Project No. 1301

Re: **Clair-Maltby 11.3 Draft Secondary Plan
 Final Draft for Community Engagement June 16, 2021**

I am the planning consultant providing these comments on behalf of the owners of 132 Clair Road West located in the northwest portion of the Clair-Maltby Secondary Plan abutting the existing South End Community Park.

Schedule B – Land Use Plan (DRAFT)

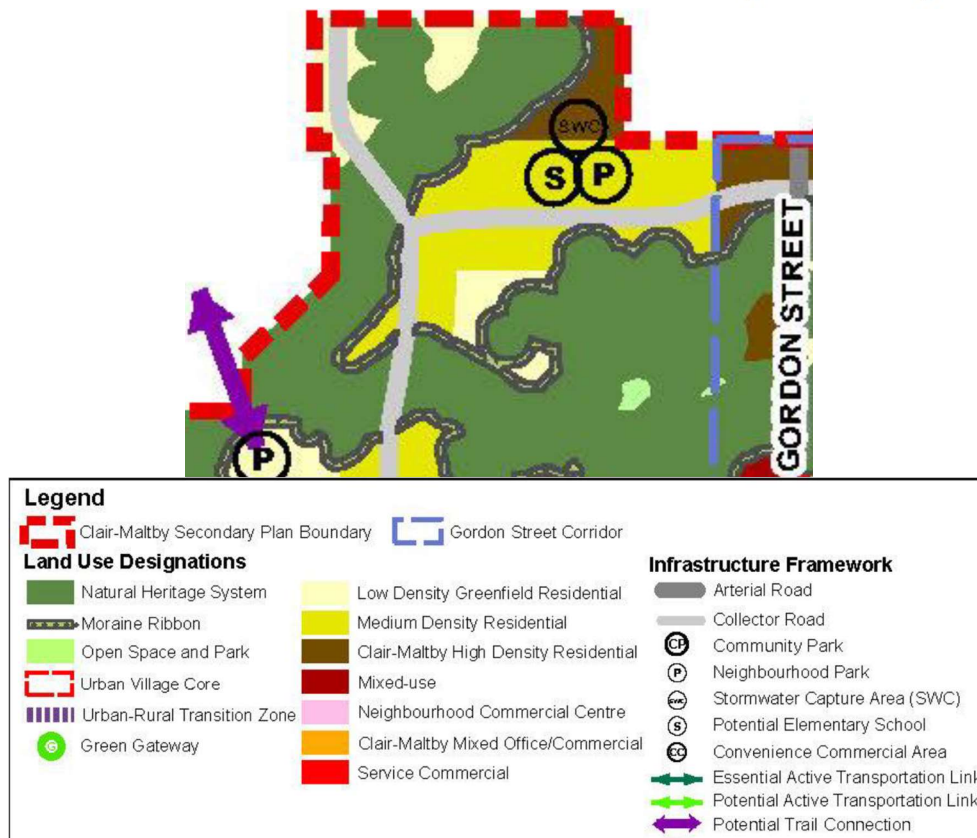
As noted in the letter from the owners' solicitor, the Draft Secondary Plan mapping is not consistent with the **OPA No. 42 settlement mapping**. The newly identified and proposed Natural Heritage System designation located in the south portion of the property and the moraine ribbon are land takings beyond the designations within the agreed to minutes of settlement. The owners are requesting that the Clair-Maltby mapping and policies be revised to be consistent with the minutes of settlement.

With respect to the **moraine ribbon** shown in the Draft Clair-Maltby mapping, this feature is neither a required environmental element since the Natural Heritage System features and buffers are already identified and protected within the current Official Plan designation, nor is it clearly parkland dedication in the draft secondary plan policies. The moraine ribbon may be included as trails and parkland and if this is the case it should be included in the required parkland dedication requirement and be clearly articulated in the policies. Unfortunately, the moraine ribbon is not located where there are pedestrian and cycling desire lines of travel. The moraine ribbon proposal will result in land needed to provide housing and other uses within the urban area not being available. Approximately 46% of the Clair-Maltby secondary plan area is protected as part of the Natural Heritage System. In addition, there will be schools, parks, stormwater management areas and newly proposed stormwater management overflow areas, and roads which will all reduce the land available for housing and other urban land uses. The moraine ribbon should not be included within the secondary plan. Instead, there should be a policy to accept a percentage of the trail connections as part of the required parkland dedication received by the City.

The proposed **collector road** located to the east of the existing South End Community Park is not viable due to the change in grade through this location. As has been communicated to City staff previously, the collector road should be located on the other side of the wetland on the east side of the property.

The parcel abutting the South End Community Park should not be designated "Low Density Greenfield Residential". This parcel should be designated "**Clair Maltby High Density Residential**". This is an appropriate designation in this location and will assist the City in meeting the Provincial density targets.

The parcel located at the north end of the property with frontage on the extension of Poppy Drive (surrounded by wetlands) should not be designated "Low Density Greenfield Residential". This parcel should be designated "**Clair Maltby High Density Residential**". This is an appropriate high density site which would be supportive of, and walkable to, the commercial node at Clair Road and Gordon Street.

A **Neighbourhood Park** should not be identified on this property due to its proximity to the abutting South End Community Park. Cash-in-lieu of parkland in this location would be a more appropriate and better option in this specific circumstance.

The proposed **Stormwater Capture Area** does not appear to be in a logical location in accordance with the existing grades of the property. We question the stormwater management approach that is being proposed and would like to see an effective and less land consumptive option be proposed. A meeting to review the City's proposed engineering strategy has been requested and we would like to participate in this meeting.
